Purpose of Change – Base Unit

**Re: Application for a Permissive Change Filing with
FCC ID: EW780-0899-00**

The purpose of this document is to describe all the changes that are made on the Base Unit to the new designed models (**C620**) from the original model (**VDP800**, certified on **Mar 8, 2018**) in order to meet the requirements. [The Purpose of the Changes is to use the higher-speed Ethernet switch \(10/100/1000M\).](#)

KeyPCB

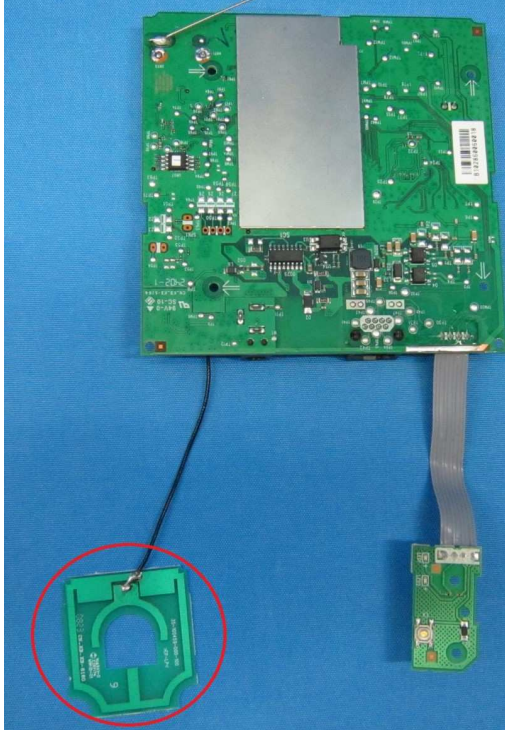
1. To add Registration Procedures on Base Unit of model C620
2. External vertical co-linear antenna will be changed to internal vertical PCB loop antenna.
3. [Key PCB layout is changed and Z1 is changed to BZT52C6V2](#)
4. [Base Main PCB layout is changed because Ethernet switch \(U9\), AR8236 is changed to \(RTL8363NB with X2 Crystal 25MHz is deleted\) and the POE controller IC \(D025\), TPS23753A is changed to SD4954B.](#)
5. [Regulator IC \(U10\), AP3406KT is added for Ethernet switch \(U9\), RTL8363NB.](#)
6. [Flash IC \(UM11\) is changed from W29N01HVSINF to S34ML01G200TF100.](#)
7. [DDR3 \(UM9\), EM6GC16E is changed to W631GU6NB-12.](#)
8. [RESET IC \(U17\), TPS3103E15DBVT is added.](#)
9. [Adding an alternative AC adaptor \(100-240VAC 50/60Hz 0.3A to 5VDC 2.0A 10.0W, Model: NBS12E050200UV, Brand: MASS POWER\)](#)
